# UNITED STATES PATENT AND TRADEMARK OFFICE

APPLICATION NO.	FILING DATE	FIRST NAMED INVENTOR	ATTORNEY DOCKET NO.	CONFIRMATION NO.
10/743,149	12/23/2003	Susuma Tanaka	0229-0787P	7468

<b>Office Action Summary</b>	<b>Application No.</b> 10/743,149	<b>Applicant(s)</b> TANAKA, SUSUMA	
	<b>Examiner</b> Steven D. Maki	<b>Art Unit</b> 1733

**FIG. 9(A)**

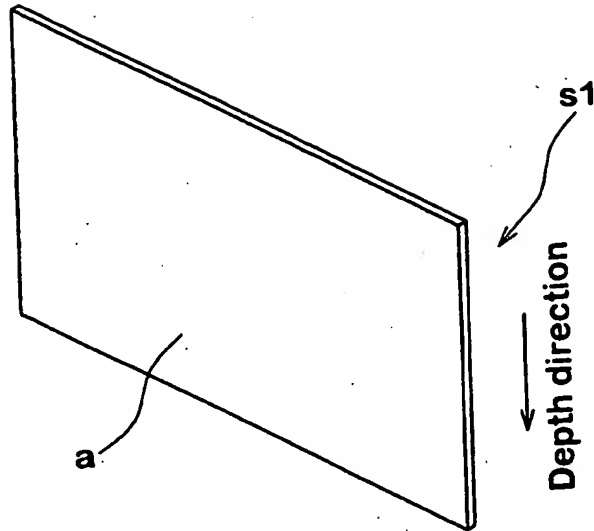
*SM* approved  
and  
4-11-06 accepted
